SUBJECT: PALISADES - NRC EXAMINATION REPORT 50-255/2000301(DRS)

Palisades Nuclear Generating Plant
NRC Examination Report 50-255/2000301(DRS)

The licensee submitted four post written examination comments. Two of the comments had the potential to affect the final grading of the written examination, questions 15, common for both SRO and RO, and question 27, SRO only. The other two post written examination comments did not affect the grading of the written examination. These two questions (questions 1 and 44, common to both SRO and RO) were submitted only for future enhancement prior to inclusion into the NRC question bank.

Question #15 (C-33 Drawings)
sh. 1 of 3

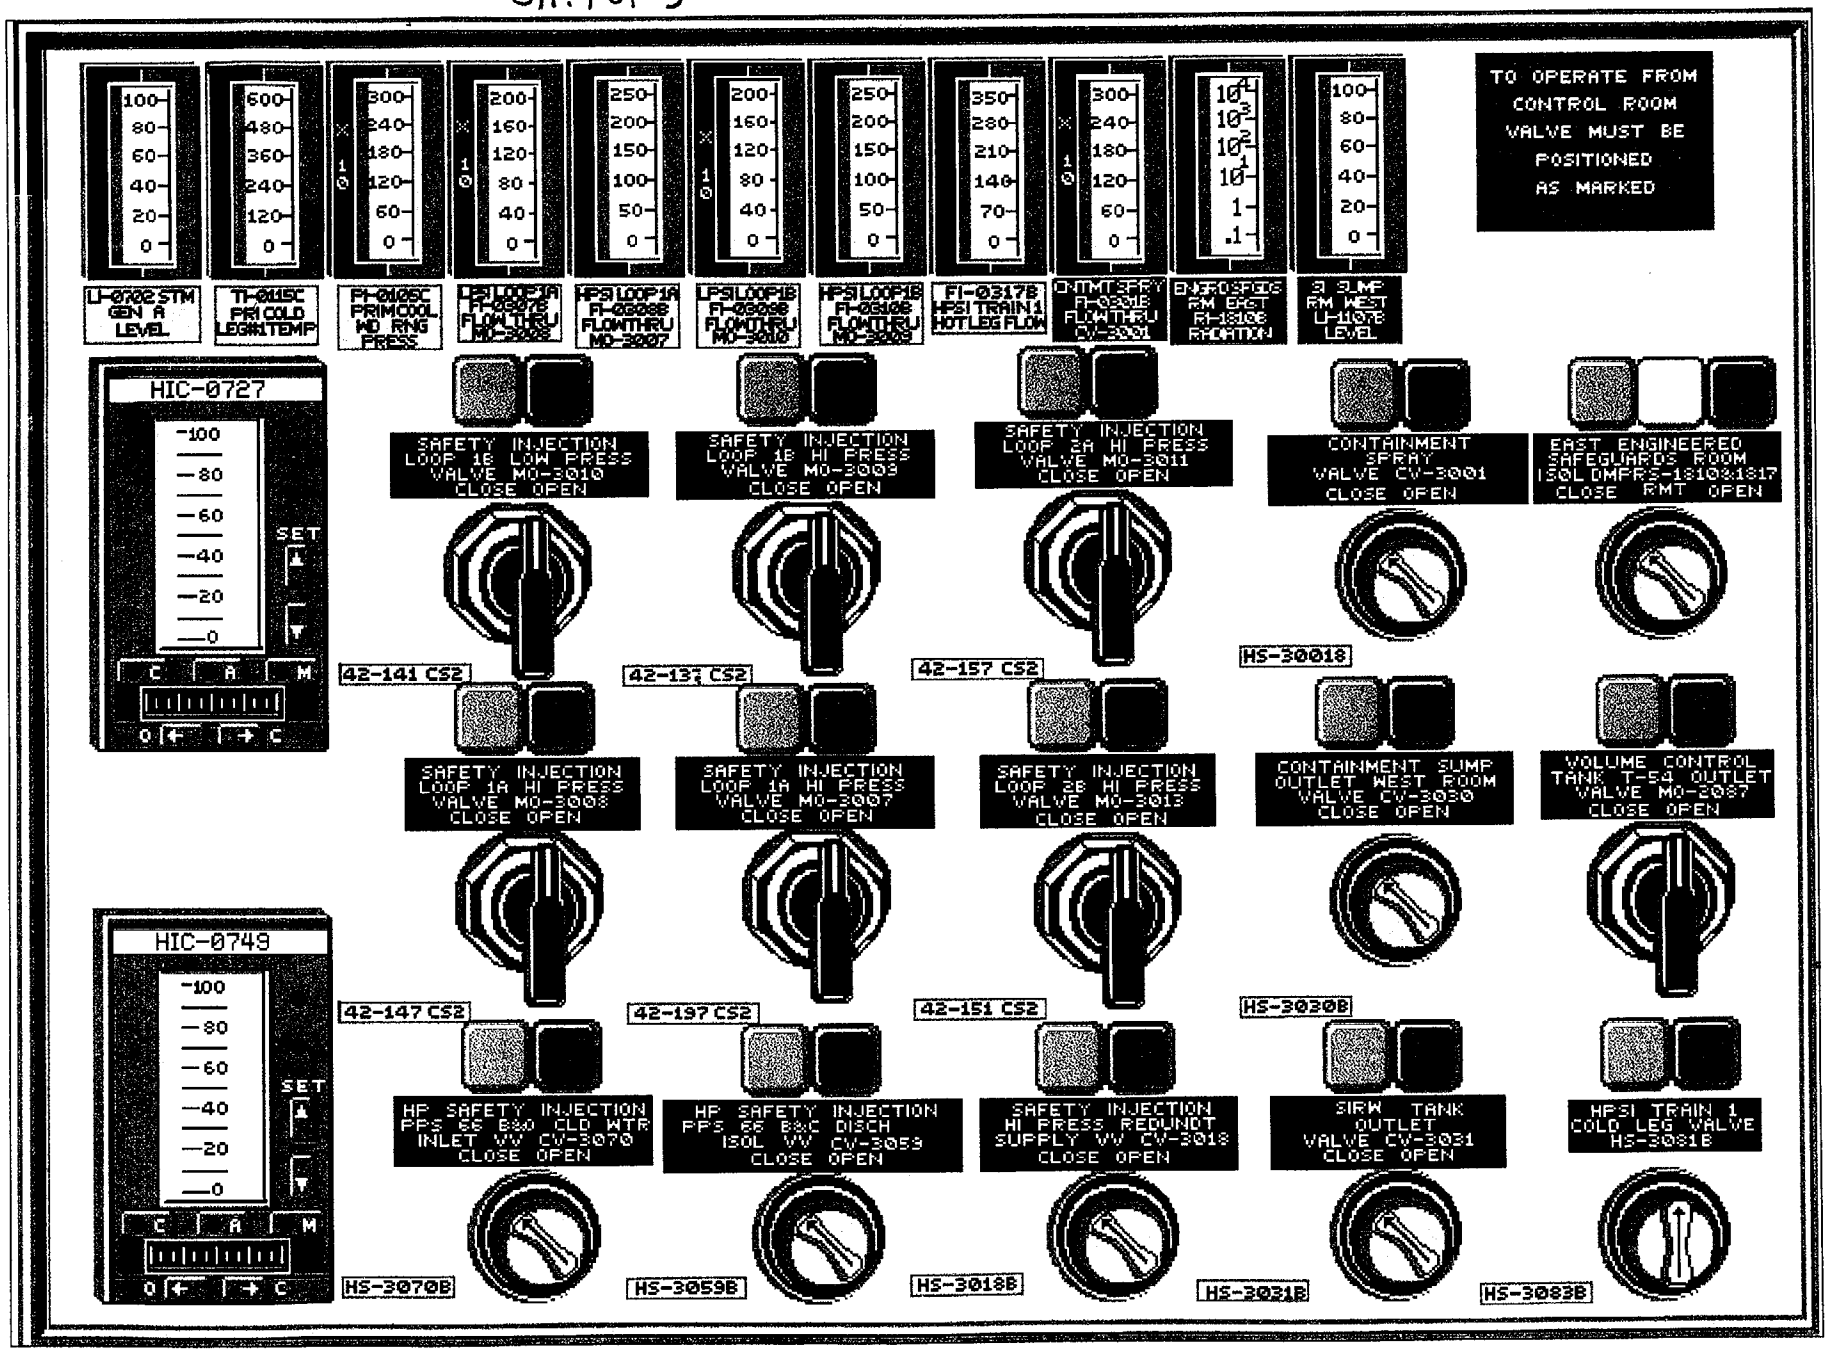
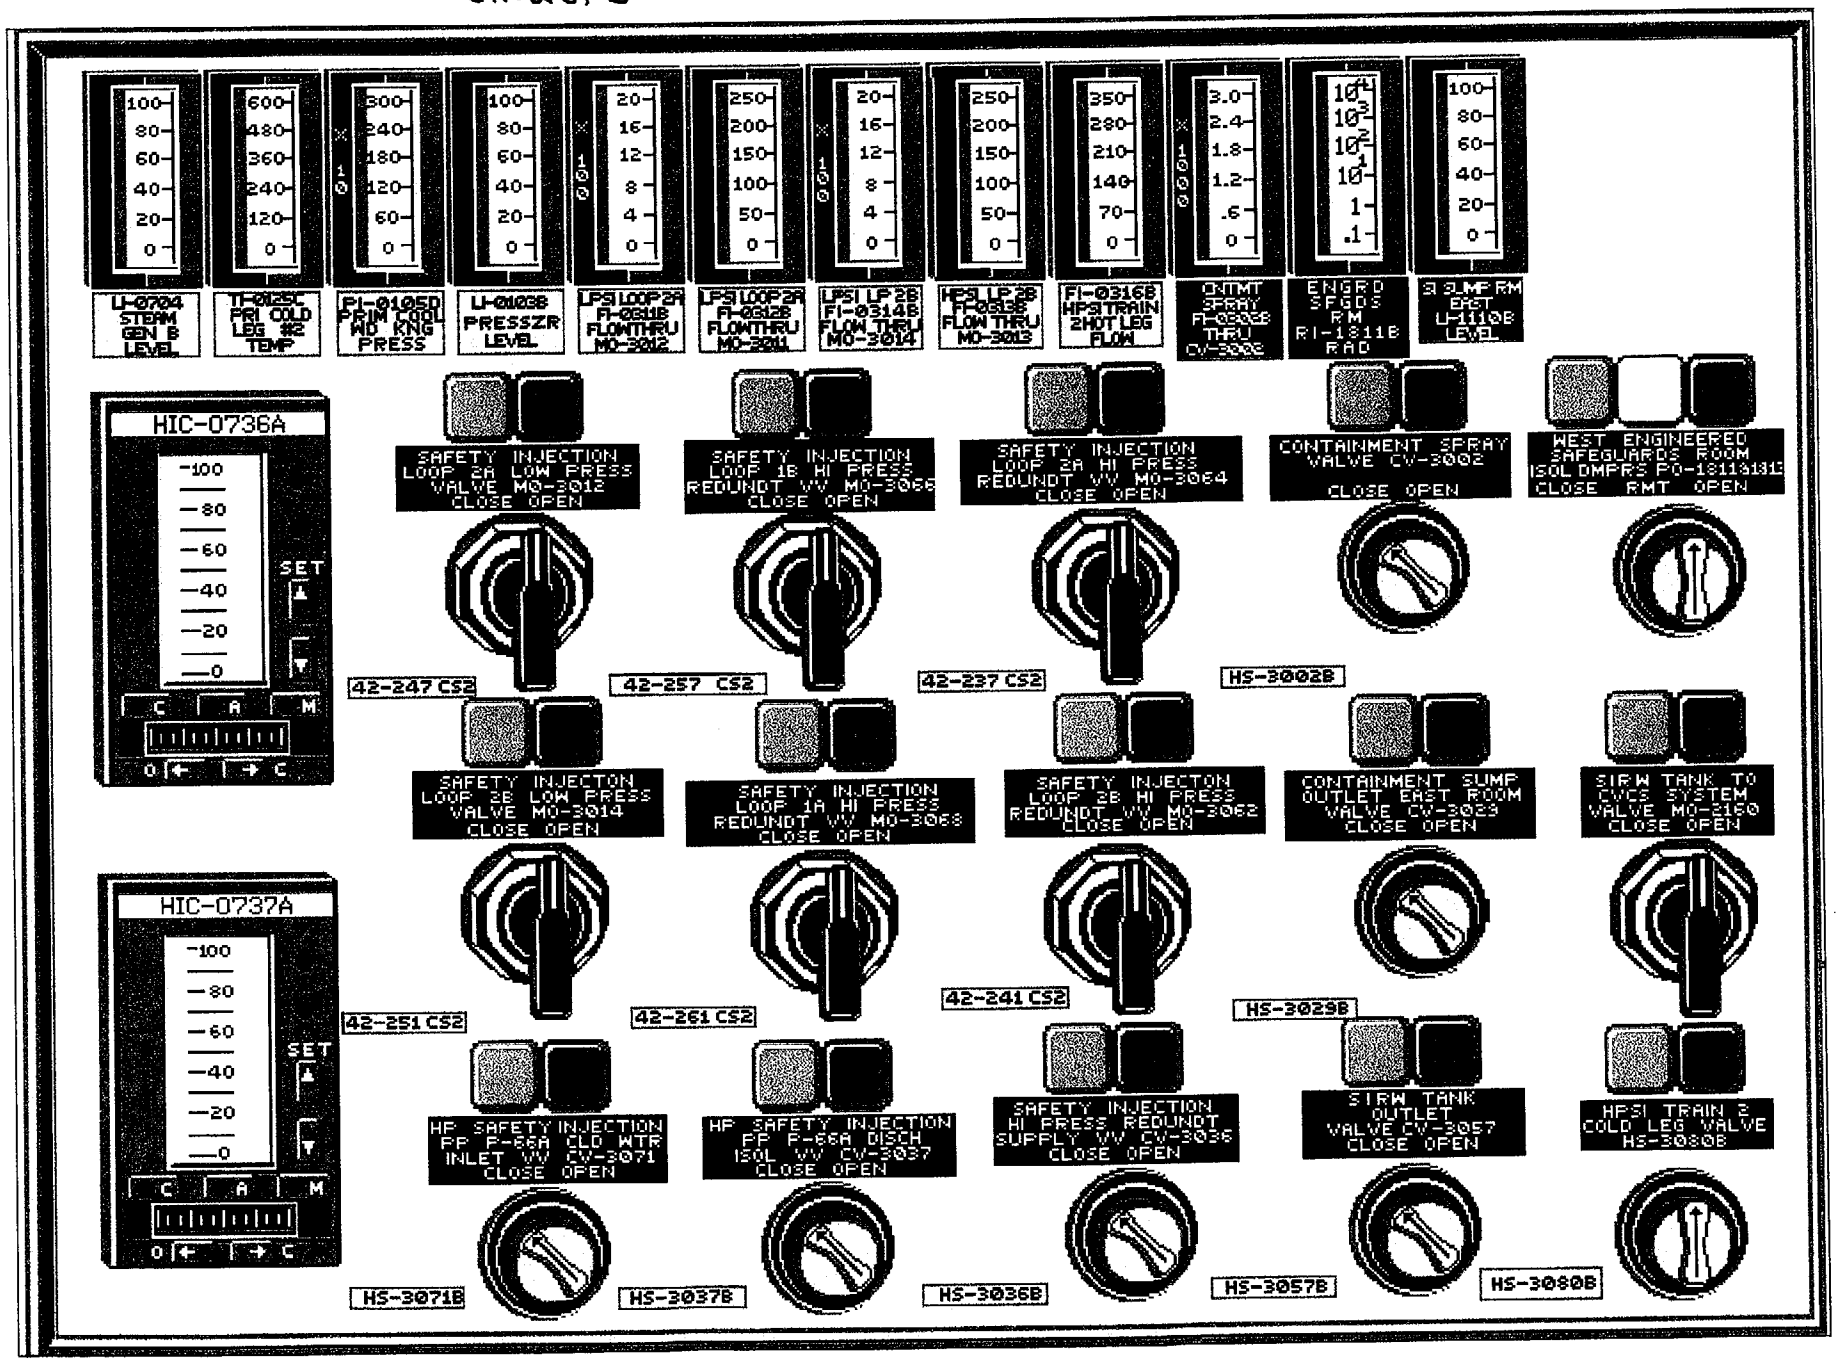
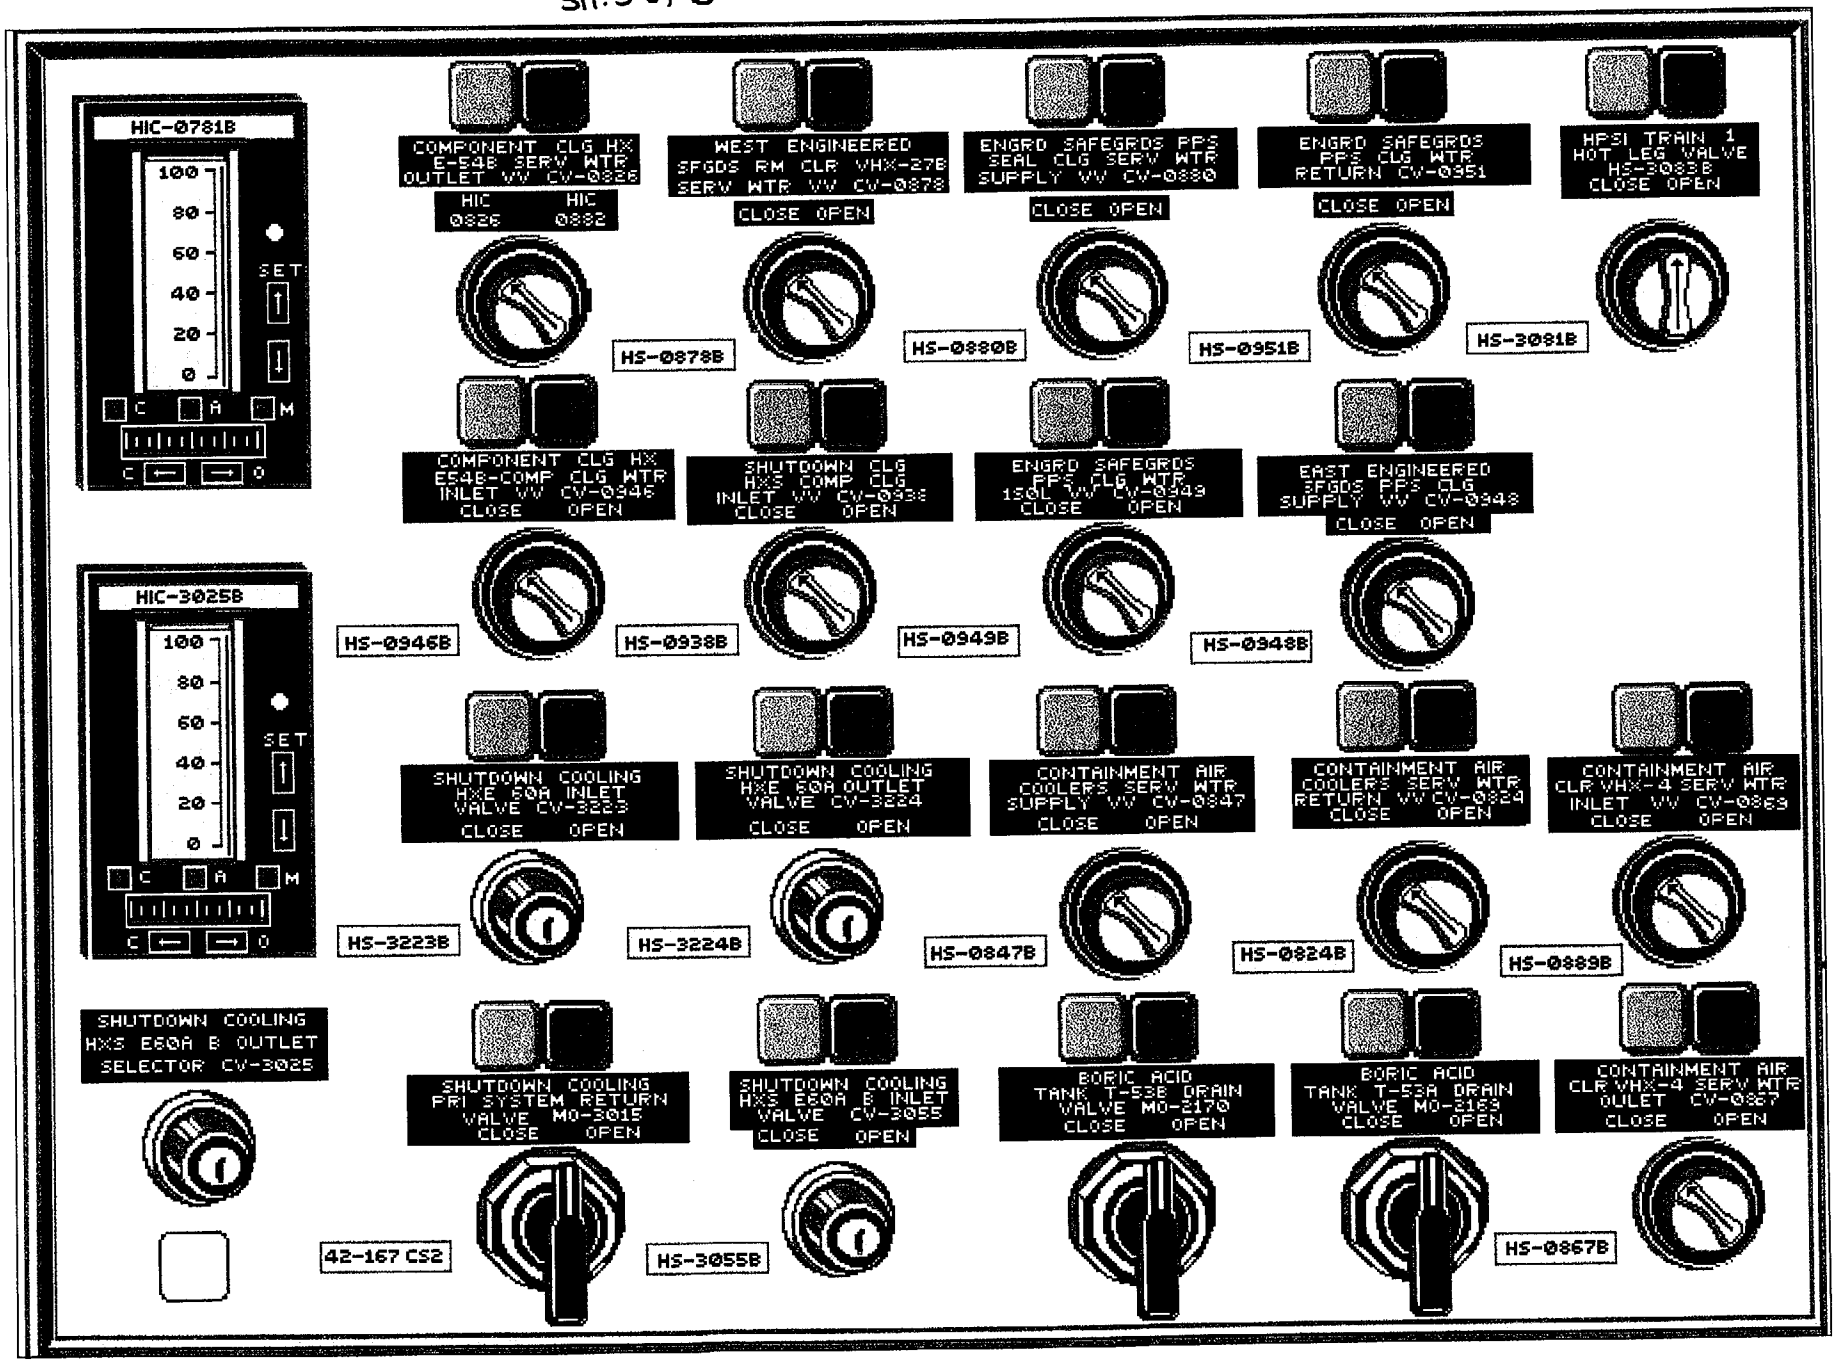
Comment:
"This question was modified during the exam administration. It became apparent that there may be more than one correct answer due to the nature of the questions raised by the students. The simulator C-33 panel was observed and it became apparent that all valves except CV-2130 were located there. The question and answer were changed during the exam to preclude subsequent deletion of the question due to three correct answers. The word "NOT" was inserted in the question stem as follows:

During the NRC review and pre-verification of the examination material with the licensee, no comments were made on Question 15. The licensee's reference and verification assured that the original selected answer "c" was the correct answer. It was initially verified by the licensee that only the valve MO-2169, choice "c", was controlled from Control Panel C-33, and that the other three distractors were not controlled from the same panel. Based on recent licensee recommendation, verification of panel C-33, the original question was technically incorrect. This was an example of poor verification by the licensee prior to submitting the examination material to the NRC. Based on review of the licensee's recent justification for question No. 15, changes to the question was accepted. The administered examination was updated to include "NOT" in the question stem, and the associated correct answer now becomes choice "a".
